**Addendum No. 1**  
**City of Coquitlam**  
**Tender No. 78035A**  
**Mariner Overpass Structural Rehab & Intersection Upgrade**  
(Consists of 5 Pages)

Issue Date: December 5, 2025

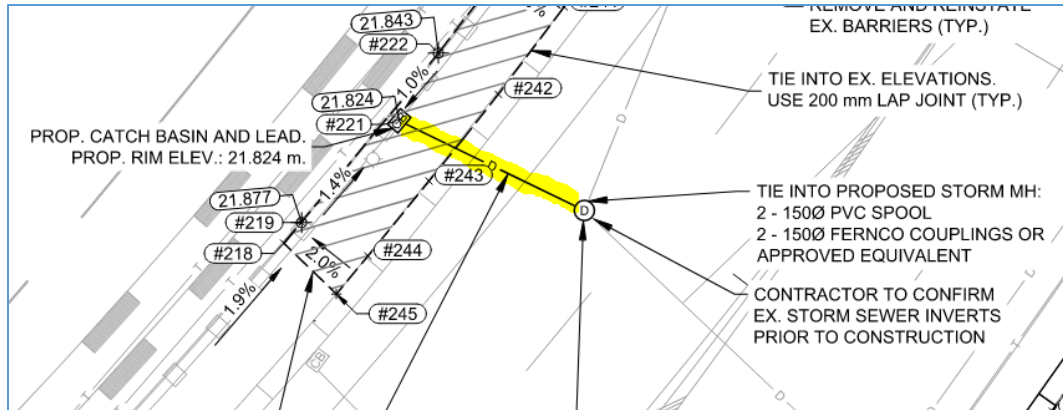
Q2) Two storm pipes are shown tying into the new manhole. Please confirm whether they are existing lines shown for reference only, or they are intended to be new installations under this contract. The drawings appear ambiguous.

A2) **Refer to Contract Drawings by Associated Engineering – BR230 Mariner Way Overpass Structural Rehabilitation.**

**Sheet 2 shows a proposed Catch Basin and Lead tying into the new drainage manhole. The proposed CB lead line is highlighted in yellow below; the existing storm pipe is shown in lighter line weight.**

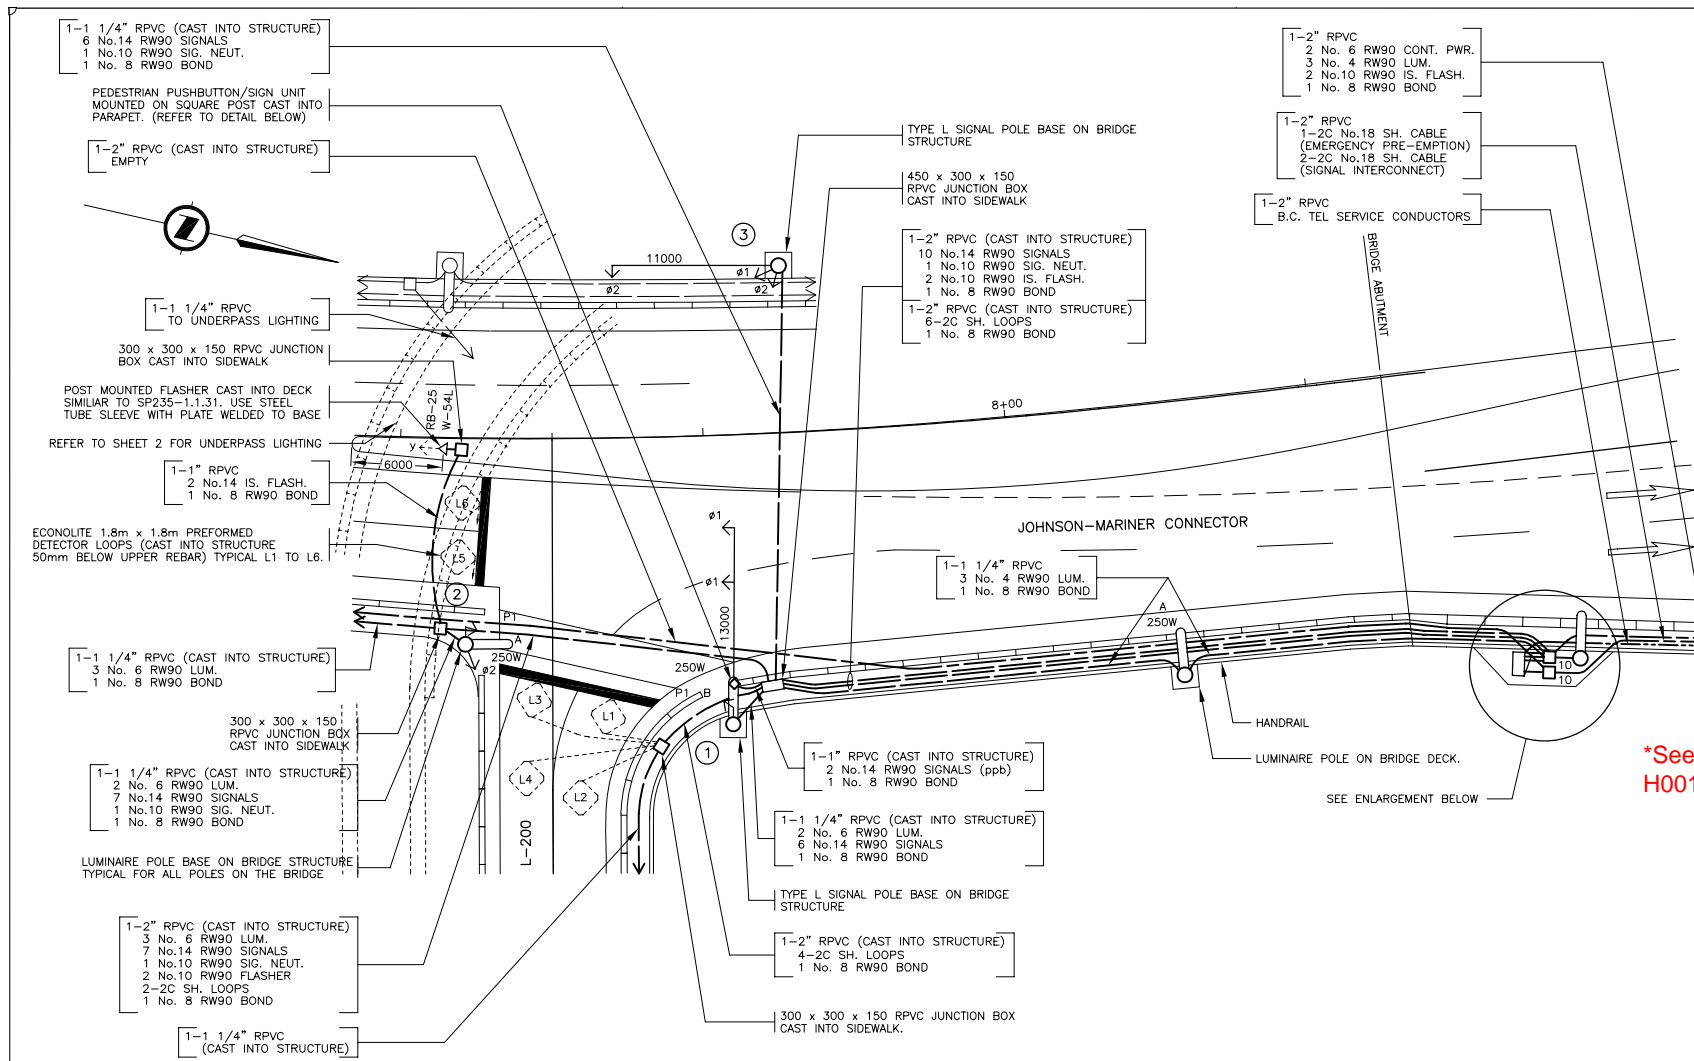
Q7) Are there dimensions of the keeper plates that you can share?

**A7) Approximate existing dimensions are shown in the sketch below. These approximate dimensions are provided for reference only. Payment applies to supply and install of the keeper plates with field-verified dimensions by the Contractor.**

**Approximately 55mm-thick of plywood padding is installed between keeper plates and the bearing. Payment for any required plywood padding is to be included in Pay Item 6.01 for the supply and installation of bearing keeper plates. After issuance of the Notice to Proceed, the Contractor is responsible for verifying dimensions onsite and**

**must provide shop drawings of the keeper plates for the Contract Administrator and Engineer's review two weeks prior to fabrication.**

**SITE PLAN ENLARGEMENT - TRAFFIC SIGNAL**

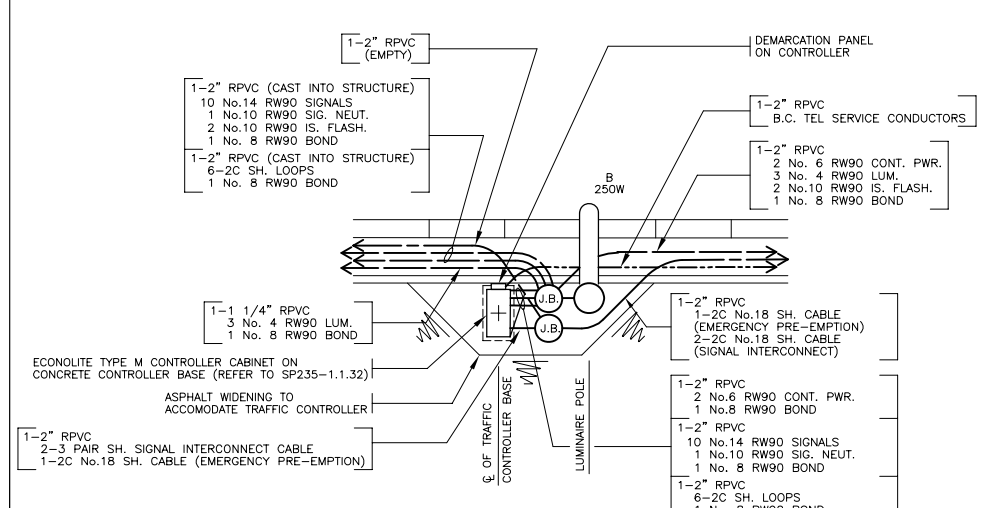
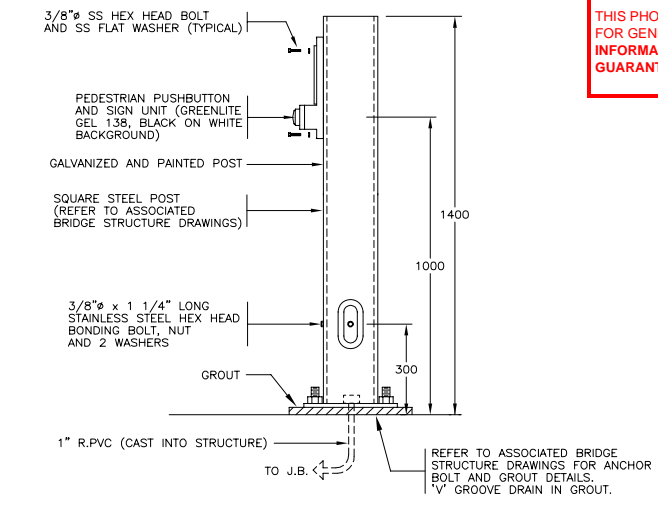
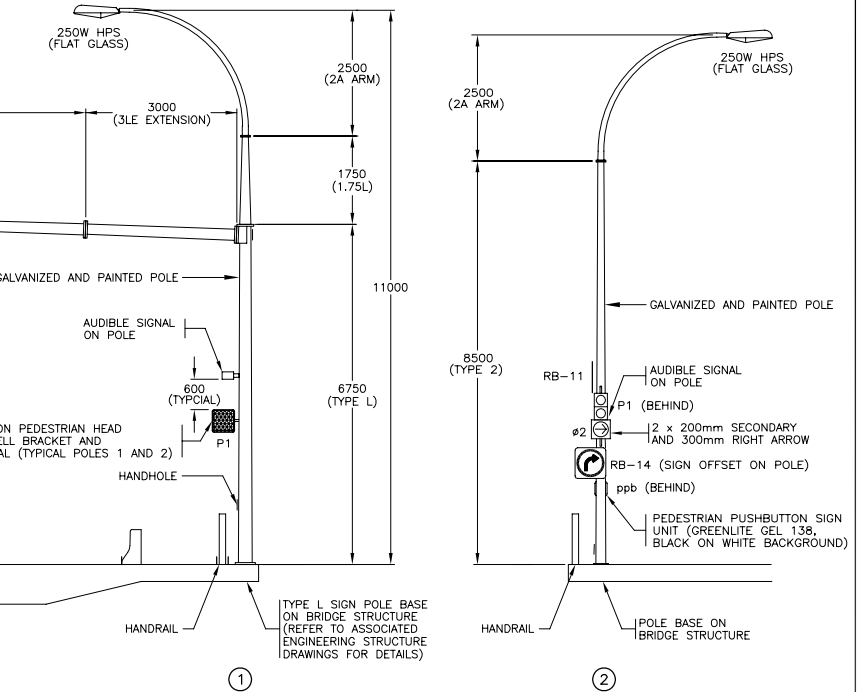
Q4) Several RPVC cable conduits were observed beneath the north abutment repair area, on both sides of the bridge. Please confirm:

- Are these cables active or abandoned?
- If active, does the contract include relocation, protection, or reinstatement?
- If relocation is required, please provide specifications or details.

**A4) Refer to added As-built Drawing No. E0958TS, pg ADD 1-5, to reference existing signal and lighting infrastructure. The Contractor is responsible to protect the Work, the Owner's property, and other person's property from Damage. The cables are to be protected during the Work.**

**Payment to protect all aforementioned property is considered incidental to the Contract.**
